# DEVELOPMENT APPLICATION ASSESSMENT REPORT

Application Number:	DA2019/1139	
Responsible Officer:	Maxwell Duncan	
Land to be developed (Address):	Lot 1 DP 204401, 19 Manly Road SEAFORTH NSW 2092	
Proposed Development:	Alterations and additions to a dwelling house	
Zoning:	Manly LEP2013 - Land zoned R2 Low Density Residential	
Development Permissible:	Yes	
Existing Use Rights:	No	
Consent Authority:	Northern Beaches Council	
Delegation Level:	DDP	
Land and Environment Court Action:	No	
Owner:	Gavin Ka-Wai Lau Fei Lin Shi	
Applicant:	Uri T Design	
	•

Image 1 - Survey Confirmation of the Height Poles

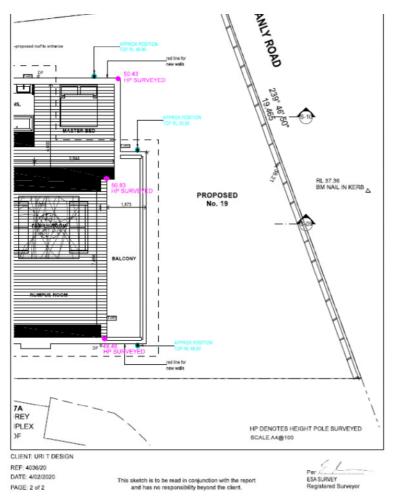
As a result of the public exhibition of the development application Council received one submission raising view loss as a concern. The submission was received from the adjoining property to the north (No. 3 Magarra Place, Seaforth). To assist Council in its assessment of the application, a request was made on 24 January 2020 for applicant to erect three (3) height poles reflecting the amended plans. Certification of the height and location of the poles provided by a Registered Surveyor on 6 February 2020. (Refer to plan prepared by ESA Surveys dated 4 February 2020).

The location of the height poles (amended) is shown below:

The proposal results in a disruption of views from neighbouring properties. The level of view loss is notunreasonable and has been assessed below with regard to the planning principle established by the NSW Land and Environment Court.
